**Solicitation No. PR10750941**  
**Tent Installation for Refinishing Area**  
**Questions and Answers #1, issued June 21, 2022**

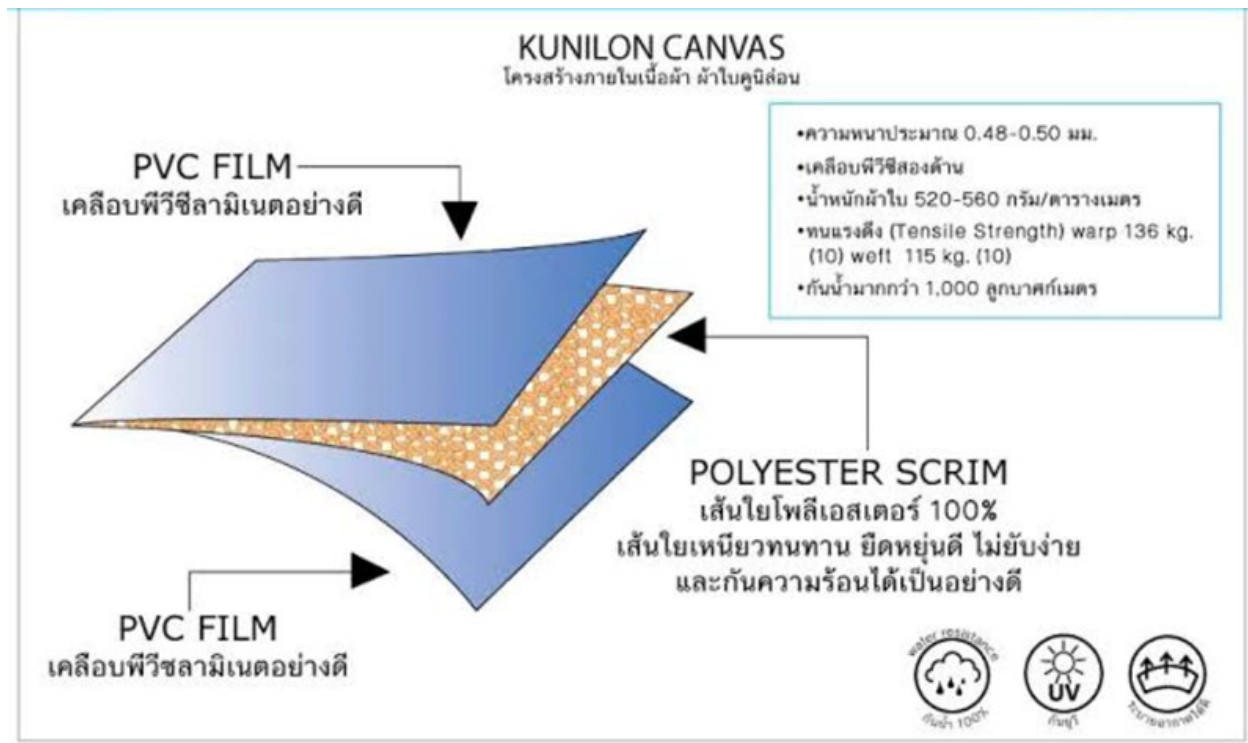
**Question 1:** Need information on the pulling force of the canvas.

Canvas specifications as follows:

- PVC coated KUNILON canvas with polyester scrim in the middle
- Warp Yarn: No. 10/1 46  $\pm$ 1 inch.
- Weft Yarn: No.10/1 39  $\pm$ 1 inch.
- Thickness: 0.48 - 0.50 mm.
- Weight 520 – 560 Gm./M2
- Tensile strength: warp 136 kg. ( $\pm$ 10), weft 115 kg. ( $\pm$ 10)
- Waterproof: Over 1,000 m2
- Color: Dark blue

Additional details as following picture:

Please be additionally informed that the wind load design for below 10 meters building-height regarding BMA code/standard =50kg/m2) should be considered as well.
